Town of Georgetown

TOWN PLANNER COMMENTS - DRAFT

AGENDA GEORGETOWN PLANNING BOARD Memorial Town Hall – 3rd Floor Wednesday, February 9th, 2011 7:30 p.m.

TYPICAL ROADWAY SECTION
NO SCALE

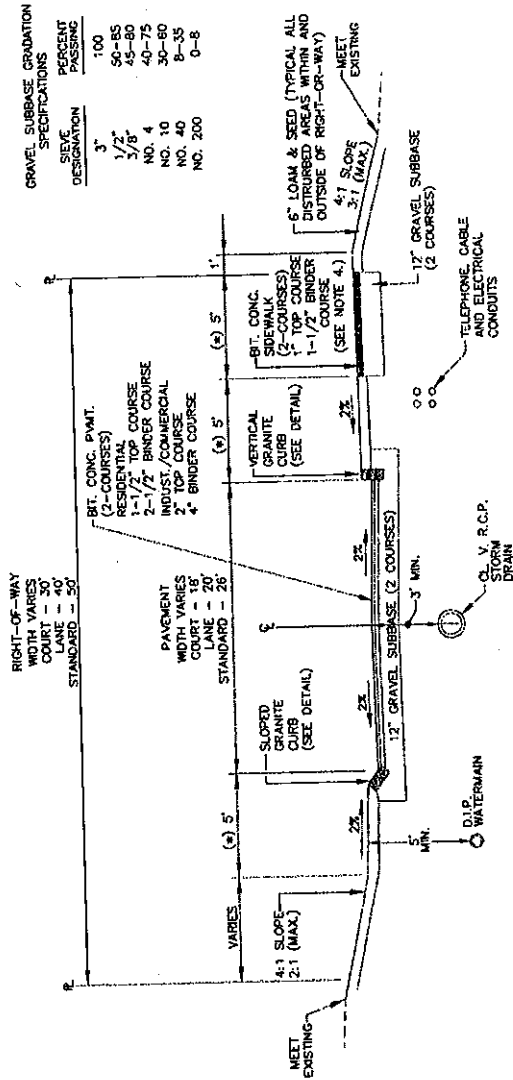
Comment [t13]: A note should be added that this typical does not include low impact development techniques...

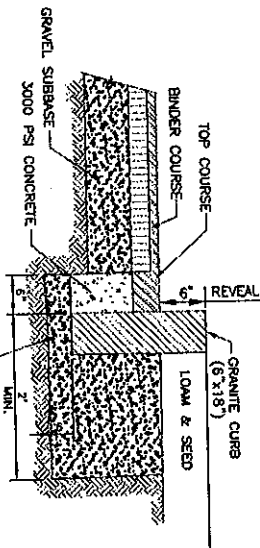
Comment [t14]: What about a no curb detail – this might be important to protect edge of pavement...

CONSTRUCTION ENTRANCE DETAIL
NO SCALE

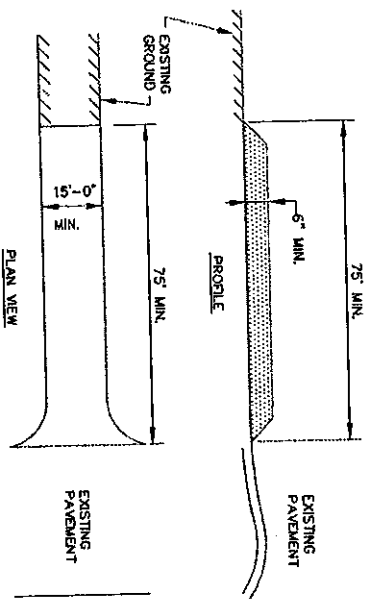
Comment [t15]: It would be nice to have a pervious pavement detail here
